# 1997 Corvette: Service Bulletin: Water Drips into Rear Compartment After Hatch/Glass Has Been Opened

**Number:** 73-10-55

**Models:** 1997 Chevrolet Corvette

Figure 1 - Sideview

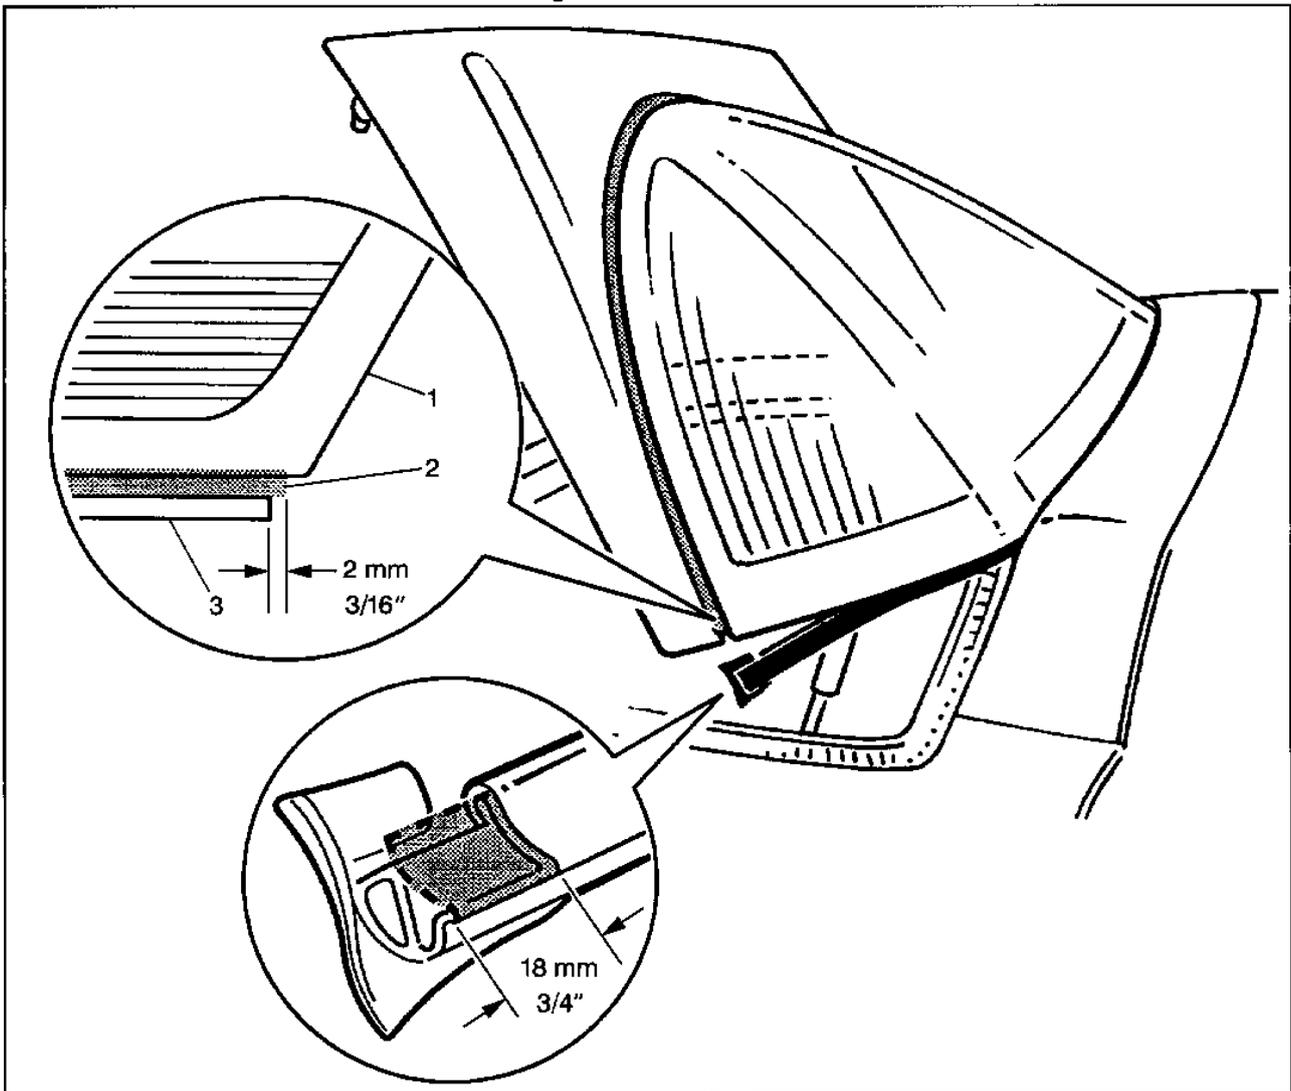
**Condition:** Some owners may comment that water drips into the rear compartment after the hatch glass has been opened.

1. Pull down weatherstrip to gain access to the end of the black close out weatherstrip (see Figure 1, top view). With a utility knife, cut the close out weatherstrip so there is a 2 MM (3/16 in.) overhang of the weatherstrip to its mounting surface (See Figure 1, top view)
2. With weatherstrip pulled down, measure 18 MM (3/4 in.) from end of weatherstrip and remove shaded area from weatherstrip (see Figure 1, bottom view). Reinstall weatherstrip on hatch.

**Correction:** Modify weatherstrip following instructions below.
